**MONITORING YEAR 1
ANNUAL REPORT**
Final

PERRY HILL MITIGATION SITE

DMS Project No. 100093
DMS Contract No. 7744
DMS RFP No. 16-007576
USACE Action ID No. 2019-00125
DWR Project No. 2019-0157

Subject: DMS Comments on Perry Hill Mitigation Site Monitoring Year 1 Report
DMS Project Number 100093

Figure 1-1b Current Condition Plan View

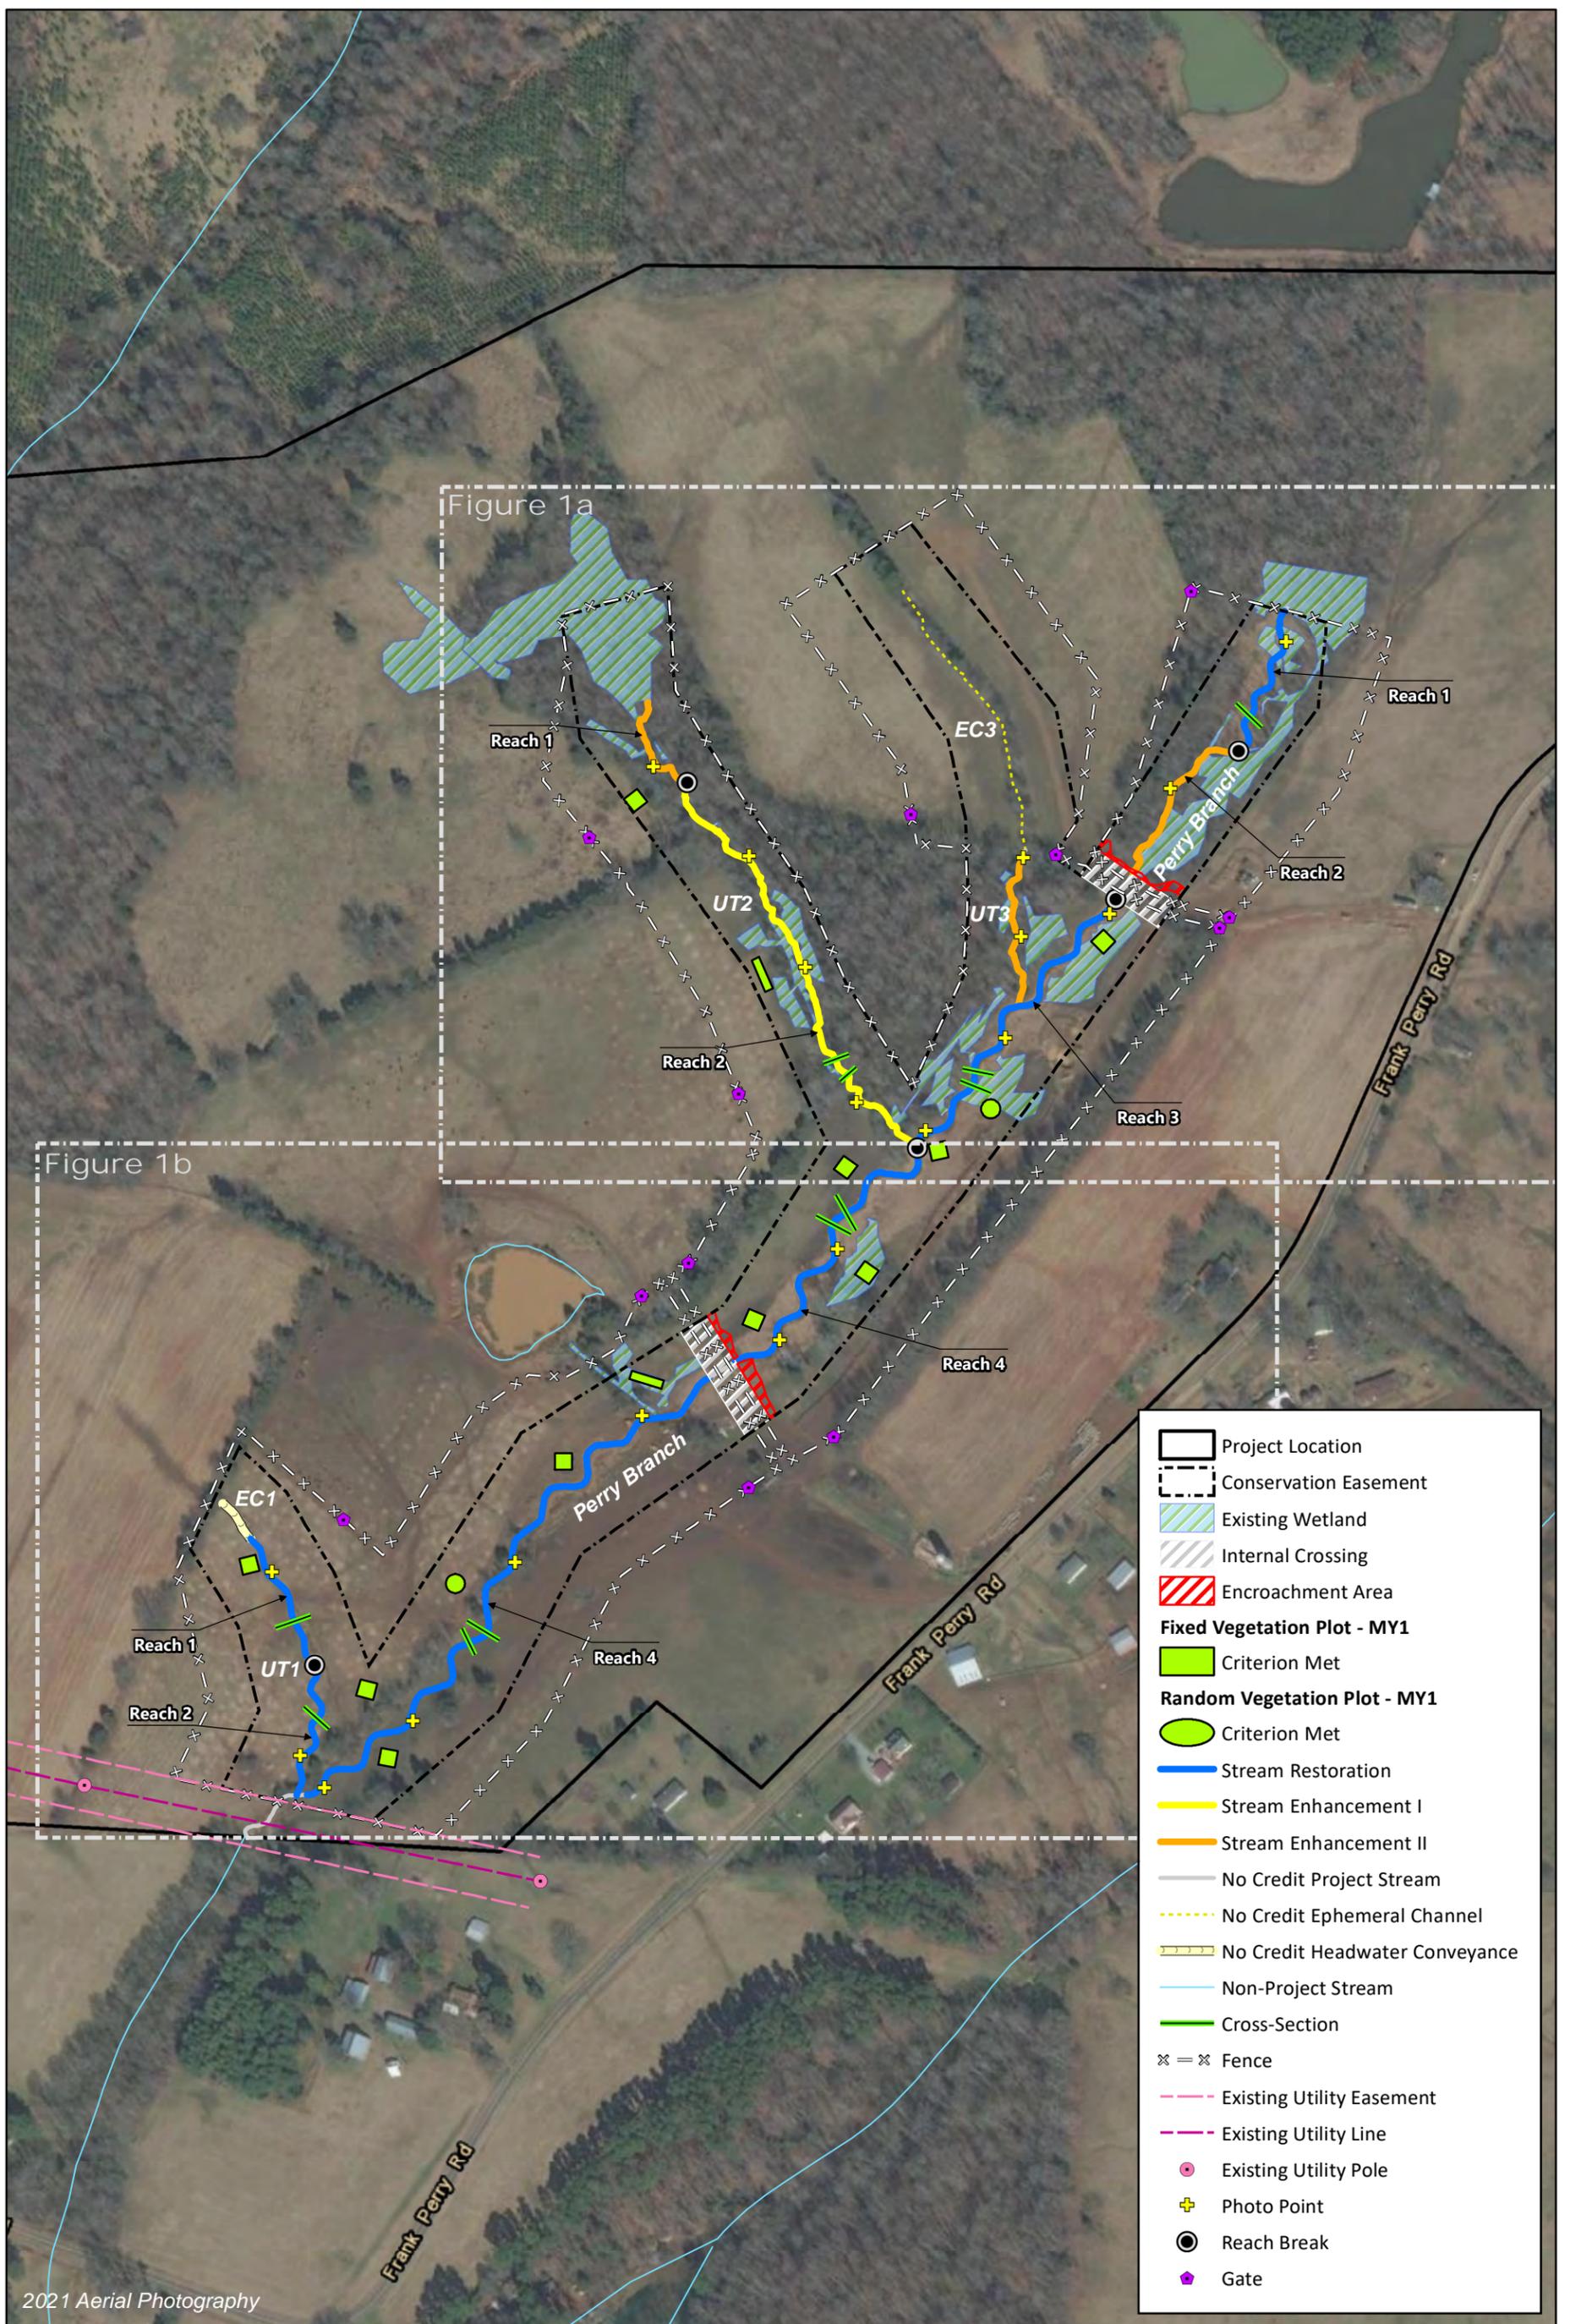
3. Figure 1 includes 14 fixed veg plots, but data for only 12 fixed plots were submitted. The submitted MY0 spatial data also included 14 fixed plots. Please clarify.

The two fixed buffer plots were mistakenly left on Figure 1 - Overview Map in the Stream Report. Figures 1a and 1b show the vegetation plots correctly. Figure 1 has been corrected.

There are 12 fixed plots and 2 random plots for the Stream Report. There are 14 fixed plots for the Buffer Report. Plots 1-12 are the same fixed plots in both the Stream and Buffer Reports. Because of the overlap, fixed plots for both projects were put in the same

Perry Branch R4 – Looking Upstream (10/21/2021)

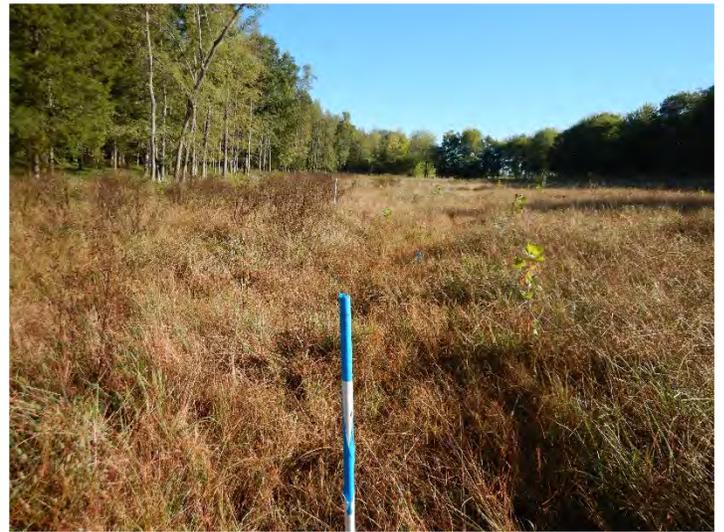
4. While photo points 7 and 8 are located in the vicinity of the Reach 4 crossing, the distance and angle makes it difficult to get a clear view of the double culverts. Please add a photo point at the downstream culvert crossing in future monitoring reports.

Wildlands plans to include a photo log of the upstream and downstream ends of both culvert crossings on site with each yearly monitoring report to allow for a clear view.

Recorded Bankfull Events

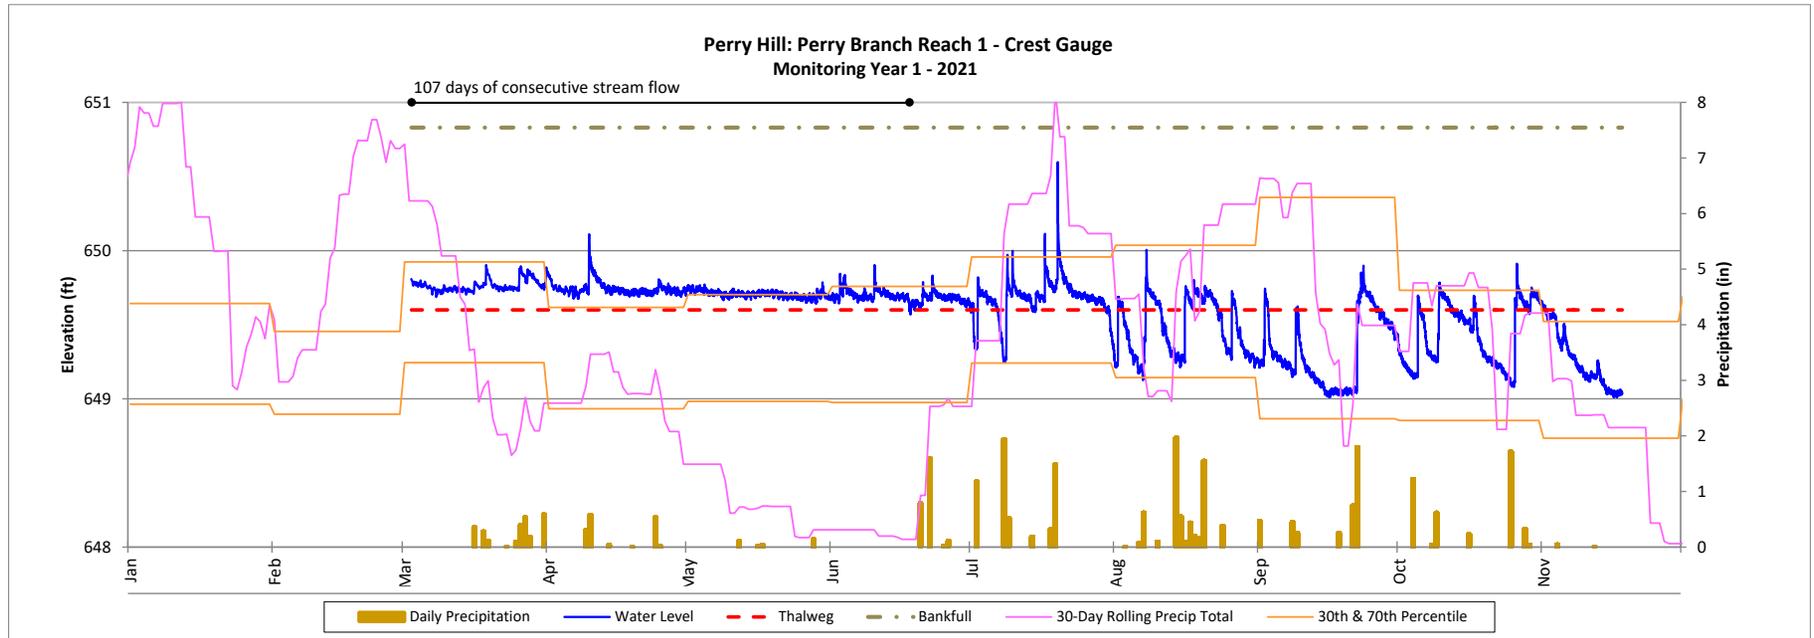
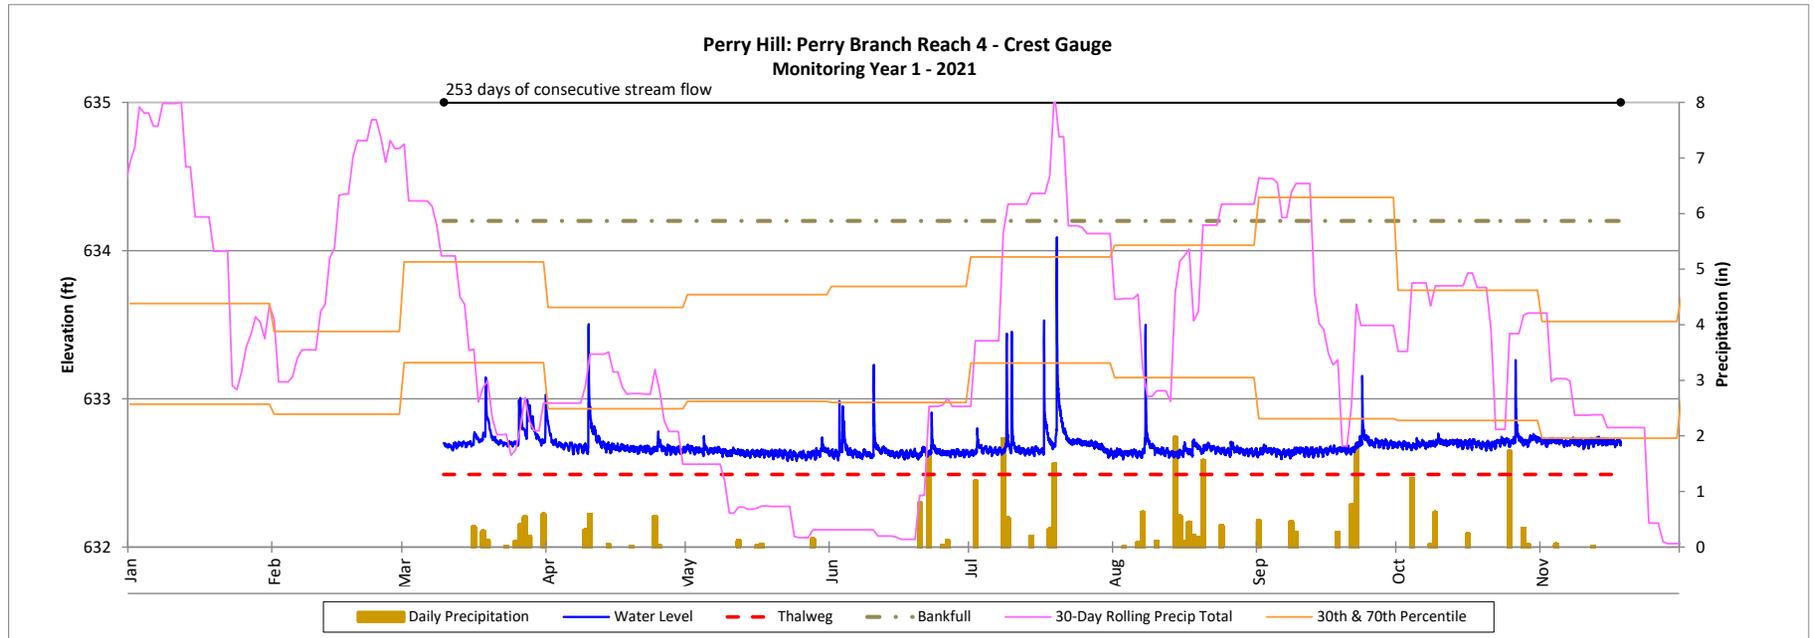
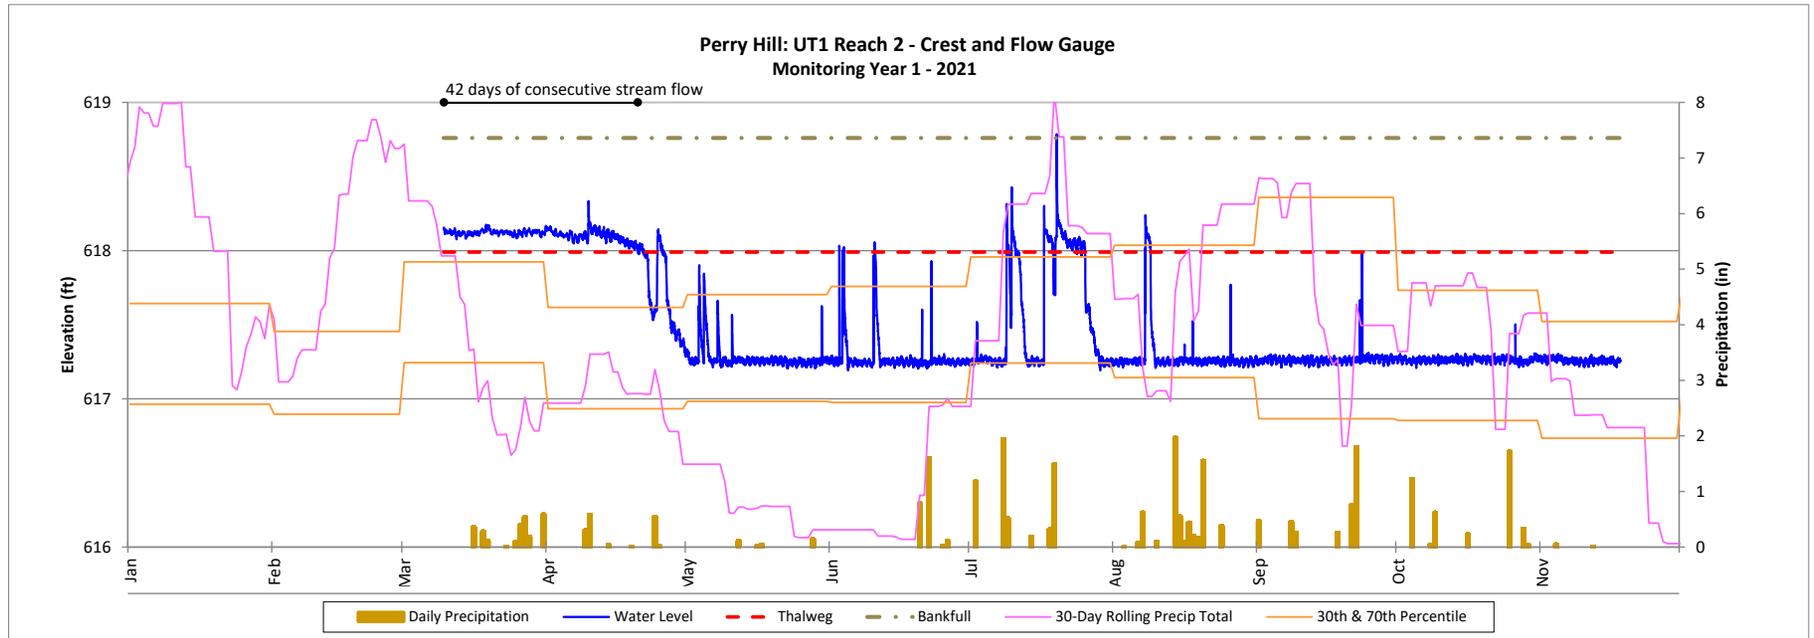
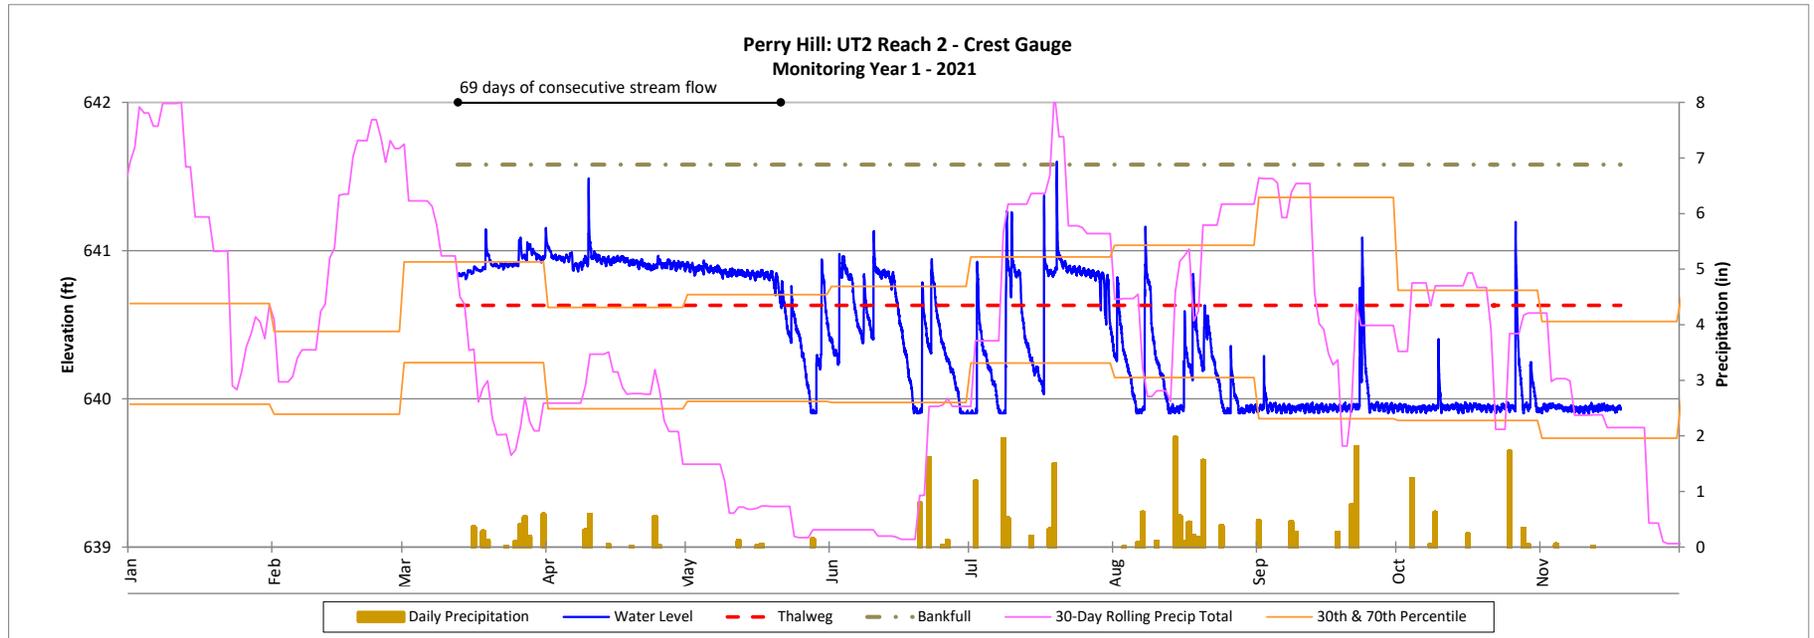
5. Please include figures that display the data for the gauges used to create Table 10.

Appendix D – Hydrology Data has been updated to include crest gauge figures.
